DISABLED ACCESS COMPLIANCE DOCUMENTATION FORM

TENANT IMPROVEMENT PLAN CHECK COMMENTS

PLAN CHECK NO:	10173635,6,7		
PROJECT ADDRESS:	1831 S Ritchey St, 1917 E St. Andrews AND 1918 E Glenwood Pl.		
PLAN CHECK ENGINEER:	Kwak, Jason	TEL: 714	647-5866
		FAX: 714	647-5897
TYPE OF CONSTRUCTION:	V B		
OCCUPANCY CLASSIFICATION(S):	B, S-1		
PLAN CHECK DATES:		REMARKS/RECHECK ITEMS:	
APPLICATION	11/7/2011	_____	
INITIAL REVIEW	11/23/2011	_____	
EXPIRATION	5/5/2012	_____	
RECHECKS:	1. _____	PROJECT APPLICANT CONTACT PERSON:	
	2. _____	Michael Santillan	
	3. _____	TEL:	(949)716-9990
VALUATION:	\$30,000.00	FAX:	_____
FLOOD ZONE:	X-0602320277J	EMAIL:	michael.santillan@nationaleng.com

RE: 1917 E. St. Andrew Place
Plan Check # 10173636

SHEET NUMBER:
A-1

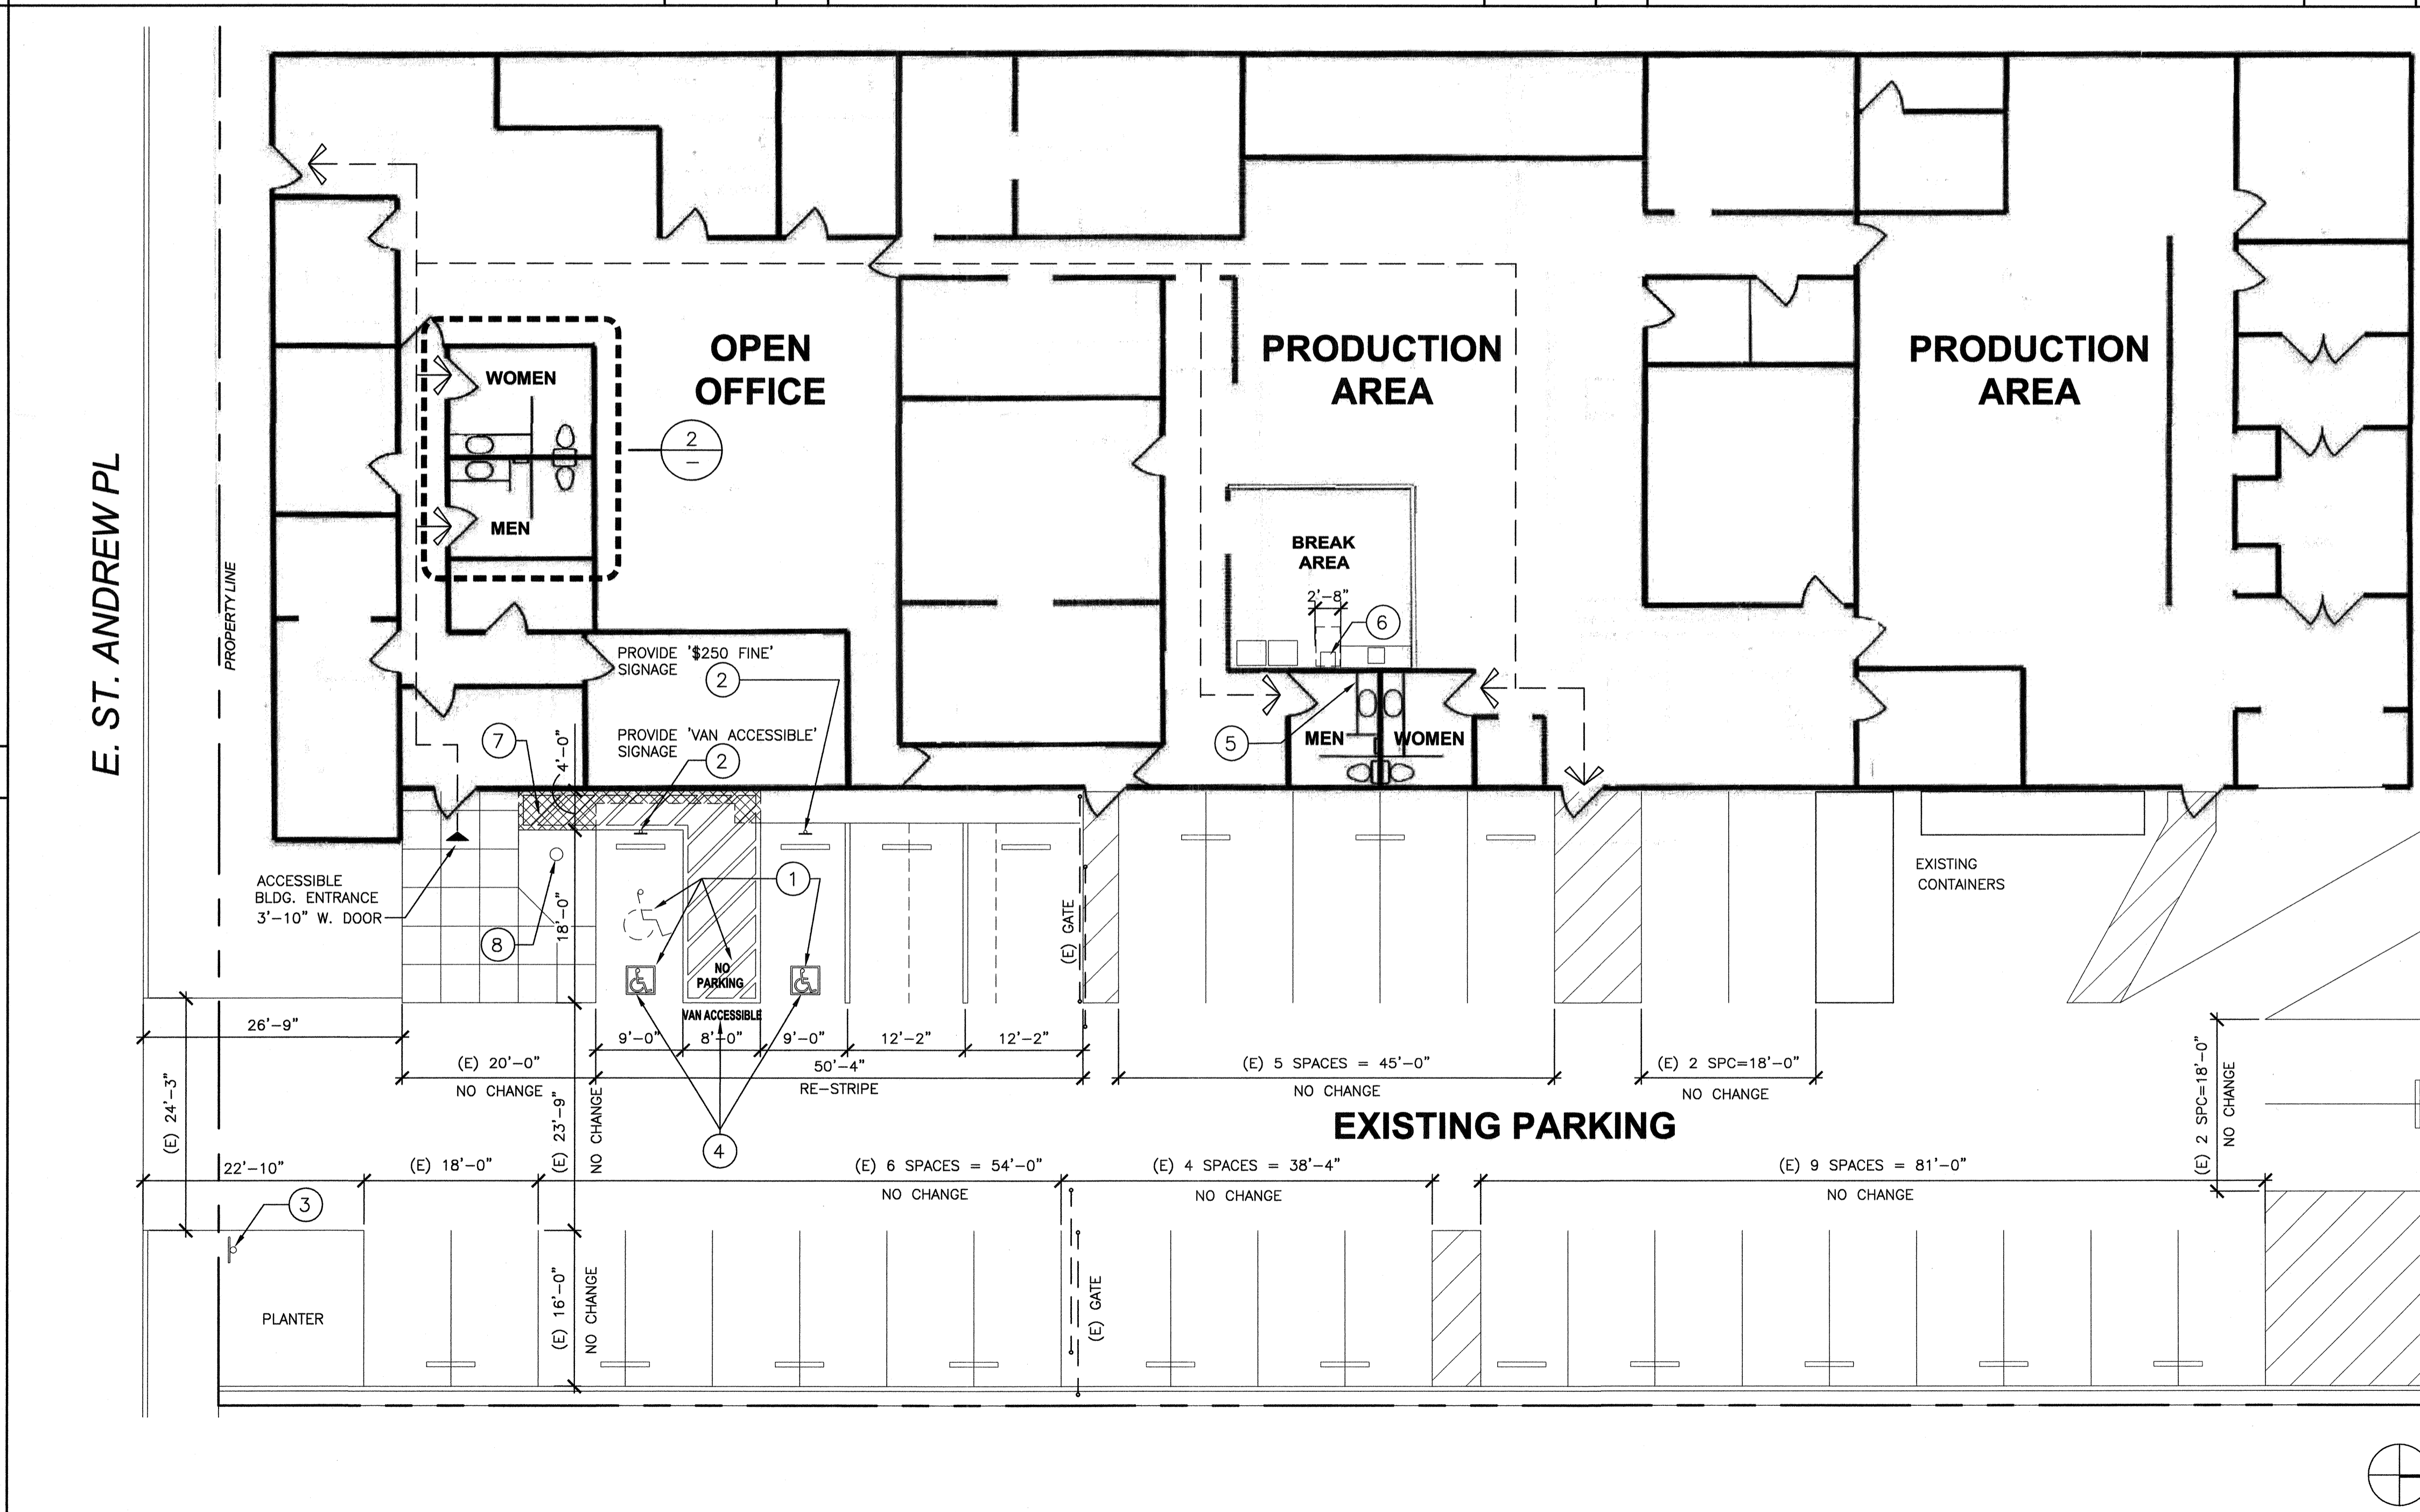
5. The drawings/information submitted for Building Safety Division review is incomplete. The applicant shall, prior to resubmitting, complete all construction documents to show compliance with the 2010 California Building Standards Code with local amendments. – Provide required disabled accessible upgrade proposal with plans.

*The drawings/information submitted for Building Safety Division review is incomplete.....-
Provide required disable accessible upgrade proposal with plans.*

It is the project designer's/property owner's responsibility to show compliance on the drawings with all applicable Federal and State Accessibility Standards

-Response: See sheet A-1, which shows proposed ADA upgrades

-Response: Proposed ADA upgrades are now shown on the new sheet A-1

-Response: see sheet A-1

- 1 REMOVE (E) STRIPING AND RE-STRIP (E) H.C. SPACE PER DETAILS: (5) (6)
- 2 PROVIDE (N) ADA SIGNAGE (7)
- 3 PROVIDE (N) ADA SIGNAGE AT MAIN PARKING ENTRANCE (8)

- 4 PROVIDE (N) H.C. STRIPING & 48" WIDE STRIPING FOR PATH OF TRAVEL AND 12" HIGH LETTERS "NO PARKING" & "VAN ACCESSIBLE" PER DETAILS: (5) (6)
- 5 RELOCATE EXISTING PAPER TOWEL DISPENSERS SO THAT DISPENSER PORTION OF UNIT IS 46" A.F.F., MAX. (VERIFY IN ALL RESTROOMS)

- 6 REPLACE (E) DRINKING FOUNTAIN WITH A NEW ADA COMPLIANT DRINKING FOUNTAIN. SEE BELOW FOR SPEC. MAINTAIN 2'-8" SIDE TO SIDE CLEARANCE, AND A 30"x48" CLEAR FLOOR AREA IN FRONT OF FOUNTAIN.
NEW DRINKING FOUNTAIN SPEC:
 BRAND: ELKAY
 MODEL # EZSDL ADA BARRIER FREE FOUNTAIN
 MOUNT PER MANUFACTURER'S RECOMMENDATIONS.
